Missing Decimals

CORRECTED SCHEMATIC

AUDIO ENGINEERING • DECEMBER, 1953

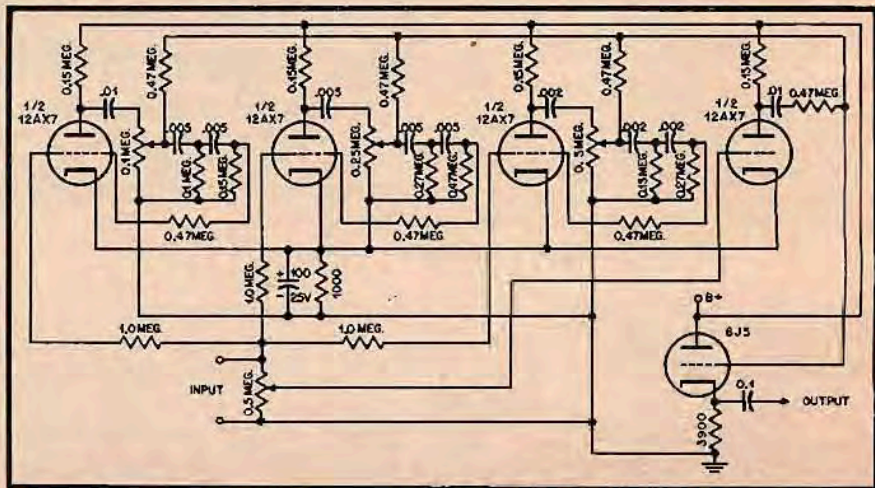
The article titled "Three-Element Bass Control" in the October issue appeared to be the best one I have ever seen. It is too bad that I can't build this control. You left off the decimal points and I can't tell if one resistor or another is required. For example, what is 01 or 047 or 005? Just where is the decimal point? And why does such a little thing get me so riled up I make all sorts of errors in typing this letter to you? (*He did, too.* Ed.)

(We're truly sorry for this condition, which has been reported by many readers. It appears that the photoengraving for the schematic was overetched, and the periods were all eaten off. However, because the circuit was of so much interest to readers, we remade the cut and a more legible schematic may be found on page 70. Ed.)

The article, "A Three-Element Bass Control" by Glen Southworth, which appeared in the October issue has been the subject of considerable correspondence from readers who were plagued by the reproduction of the schematic, Fig. 5 on page 25. Remade, the cut now shows the decimal points in more readable proportions. *Æ* regrets the inconvenience caused to any of its readers.
